Spectrum Digital Incorporated

Assembly 510840-0001

Revision: C to D

Product Name: DM36X EVM

SHEET 10

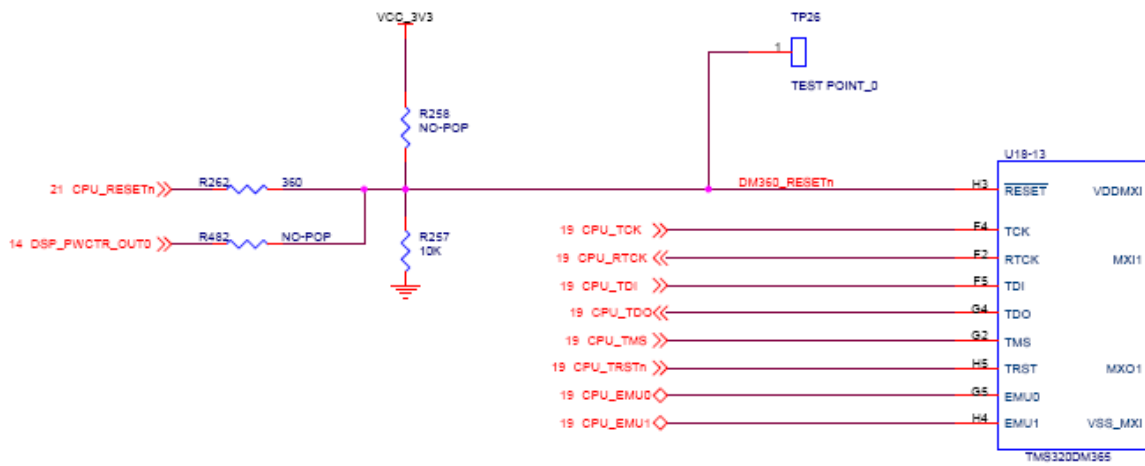
Populate R257 (0402 size) with 10K value resistor.
This removes start up glitch on Reset while CPLD is initializing.
Change provides no functional difference.

SHEET 14

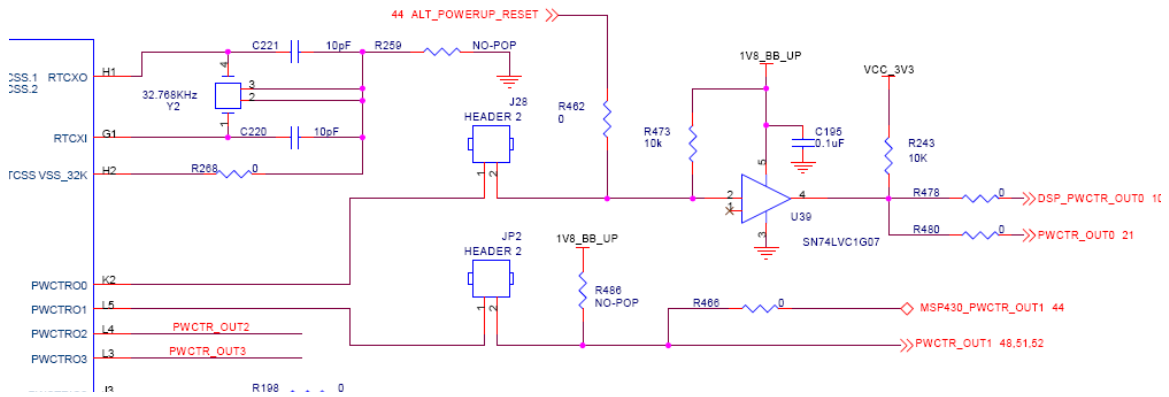
Remove R486

R486 backfeeds voltage from MSP430_PWCTR_OUT node into 1V8_BB_UP.

This causes 1V8_BB_UP domain to measure higher than 1.8 Volts
